**FINDINGS AND RECOMMENDATION
OFFICE OF PLANNING AND ZONING
ANNE ARUNDEL COUNTY, MARYLAND**

CASE NUMBER: 2025-0101-V

REQUEST

The applicants are requesting a variance to allow a dwelling addition with less setbacks and buffer than required on property located at 3801 Outrigger Drive in Edgewater.

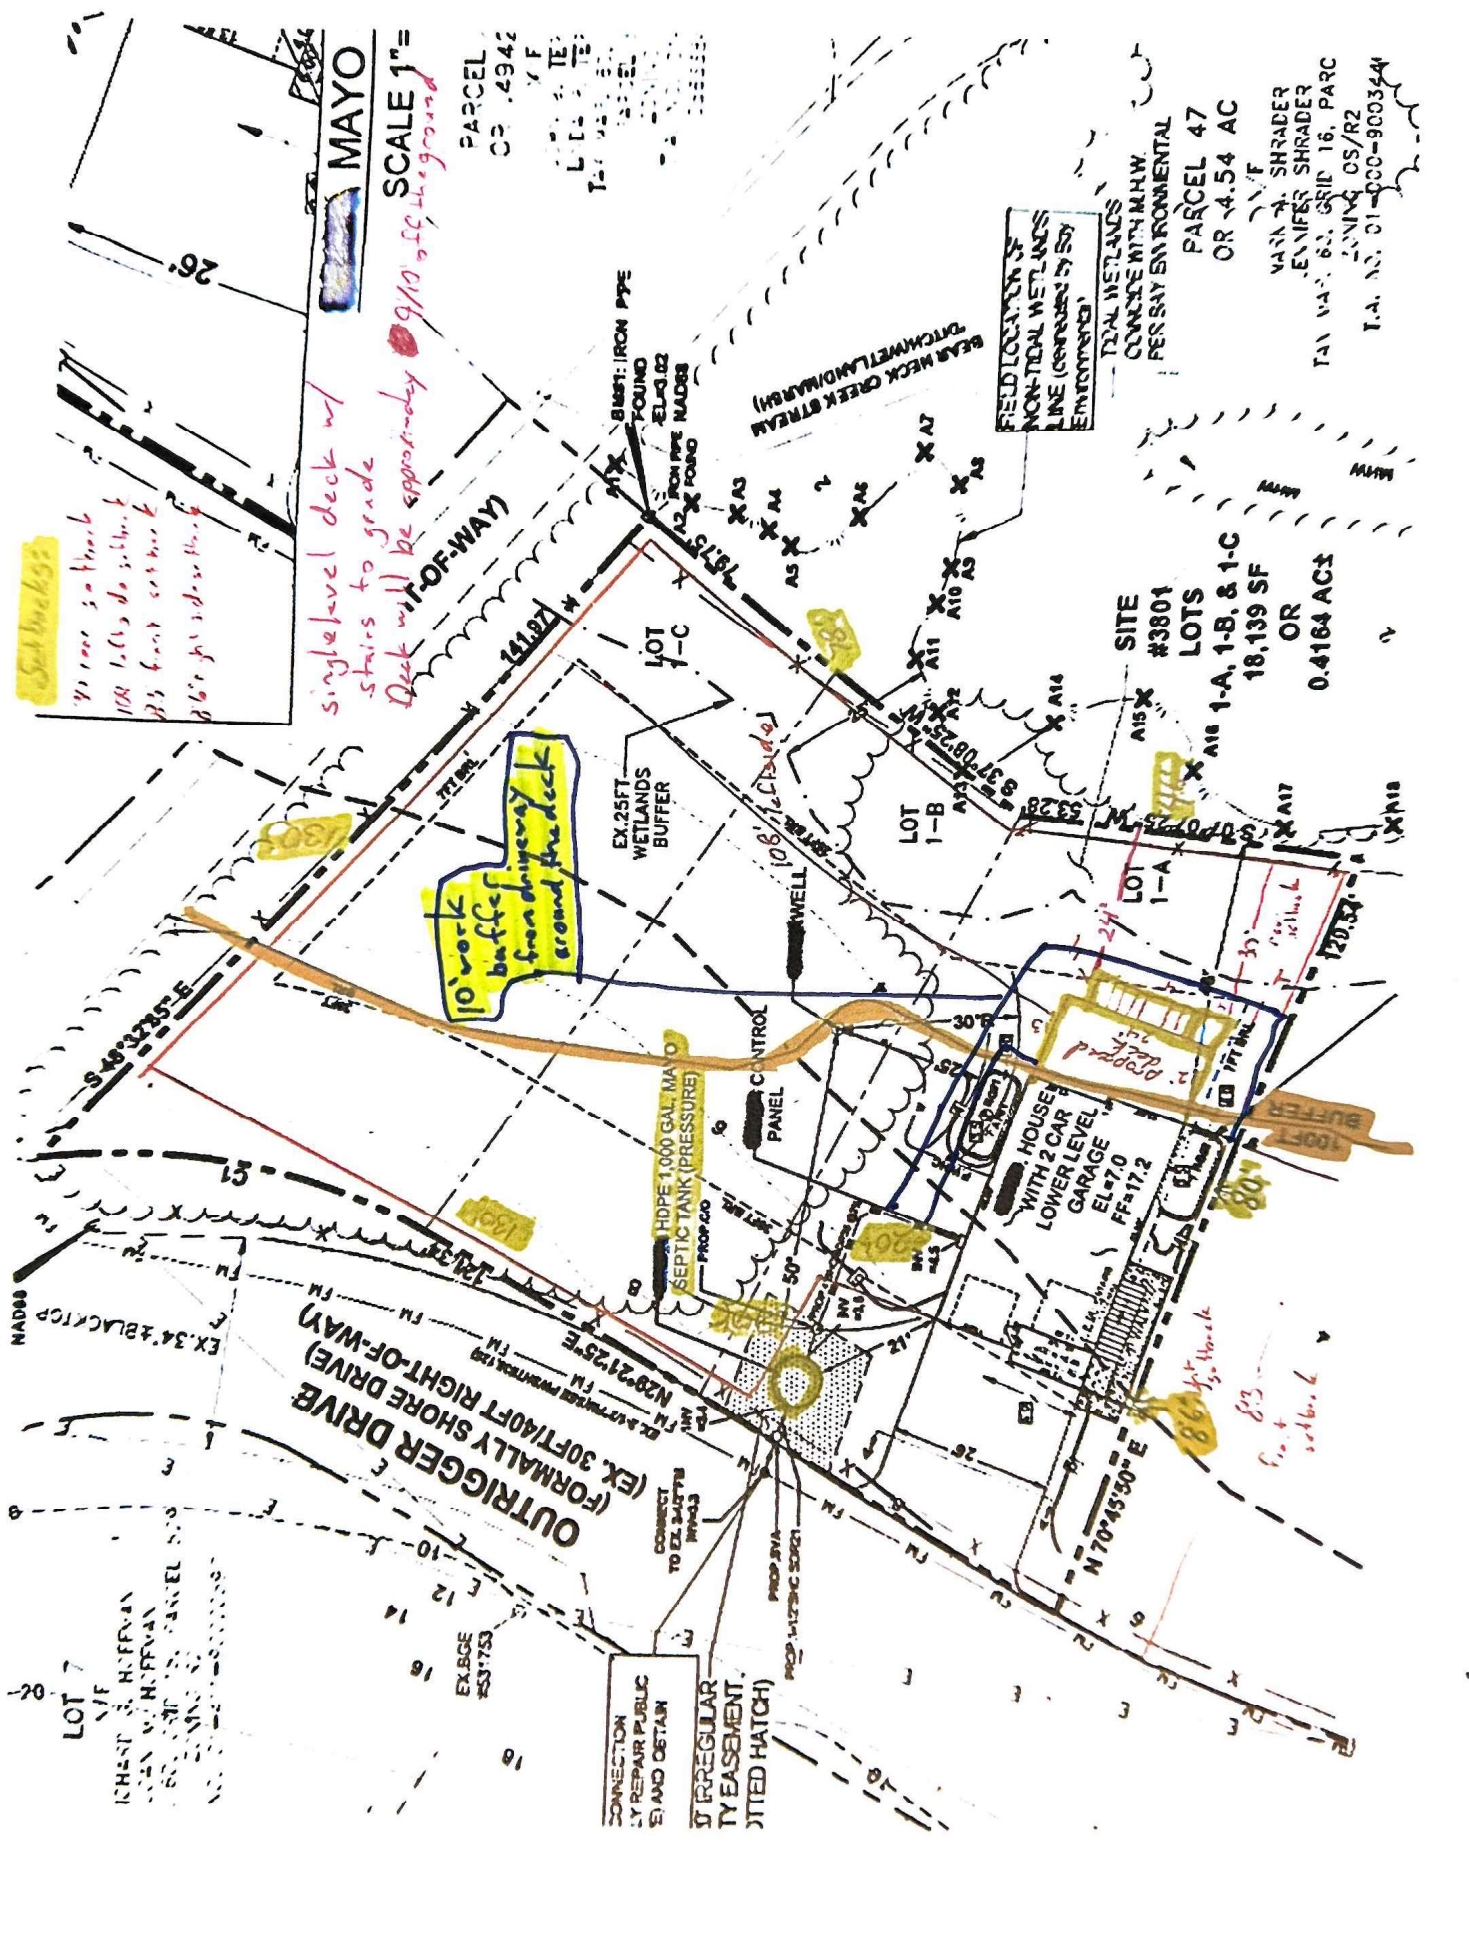
There is a 100-foot tributary stream and tidal wetlands east of the property with 100-foot buffers that encroach into the property. The proposed deck and the limit of disturbance will create temporary and

permanent disturbance to the 100-foot buffer to the stream and the 100-foot buffer to the tidal wetlands. The site plan shows permanent buffer disturbance of approximately 376 square feet and an undetermined amount of temporary disturbance in the buffer. Actual disturbance to be determined at permitting.

A setback variance for the deck and stairs is not required. While the Anne Arundel County Zoning Code, § 18-4-601, requires a 25-foot rear setback in the R2 District, § 18-2-301(b) permits architectural features without floor area, such as necessary access steps, to extend up to three feet into a required setback. The stairs are located as close as 24 feet from the rear lot line, extending one foot into the required setback.

However, the proposal results in disturbance to the 100-foot stream buffer and the 100-foot tidal wetlands buffer. While a landing and stairs could provide the necessary access to the existing rear door with a variance, there appears to be sufficient space on the north side to build a deck outside the buffer zones. Consequently, this request cannot be deemed the minimum necessary to provide relief.

Zoning Administration Section: The site plan shows the dwelling as proposed but the letter indicates that the dwelling was recently built. The site plan needs to show and label the location of the existing dwelling. The site plan shows the dimension to the rear property line from the deck but the access stairs appear to get closer to the rear lot line towards the northeast. There should be an additional label from the access steps to the rear lot line to determine if a setback variance is required. The site plan should also show the limit of disturbance (LOD) and provide the calculations on the amount of buffer disturbance. The letter of explanation does not provide any justification for the variances and also does not address any of the variance criteria, which will be required for the variance application.

With regard to the standards by which a variance may be granted as set forth under Article 18, §18-16-305. under the County Code, the Office of Planning and Zoning recommends **denial** of the variance as proposed. However, this Office has **no objection** to the **approval of a modified variance** to allow a minimal landing and stairs from the rear door with less buffer than required.
